P 516033

ON-SITE SEWAGE DISPOSAL SYSTEM HOWARD COUNTY HEALTH DEPARTMENT BUREAU OF ENVIRONMENTAL HEALTH

SUBDIVISION: Wellington West II LOT NUMBER: 11

ADDRESS: 15265 Bucks Run Drive PROPERTY OWNER: Pulte Home Corp.

TRENCH DATA

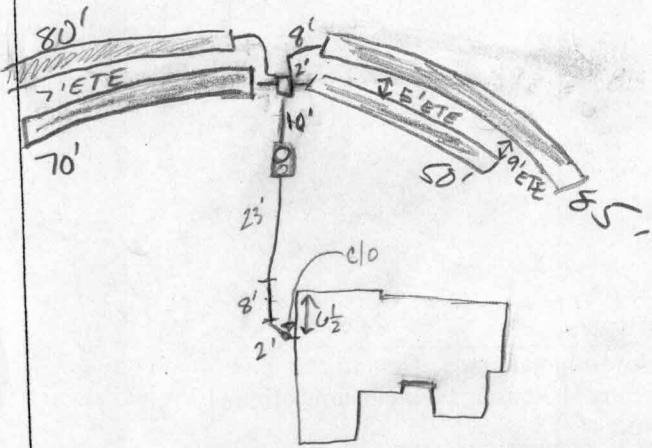
LINEAR FEET OF TRENCH REQUIRED: ~~300~~ 290 (KG/MLK)

Bucks Run Road
 PRE-CONSTRUCTION INSPECTION: 10/5/01 PER Mark's Advice/review, trenches on left side 75', 85' ; trenches on right side 50' & 80'. 7' ETE. Keep inlet, width, stone, etc the same. (KG)

FOUNDATION DETAIL

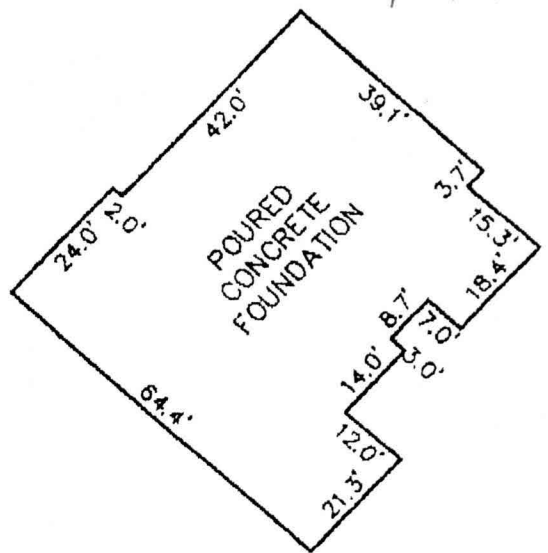
*will check - OK
House approx. in same
location as a BPP plan
RPP 9/19/01*
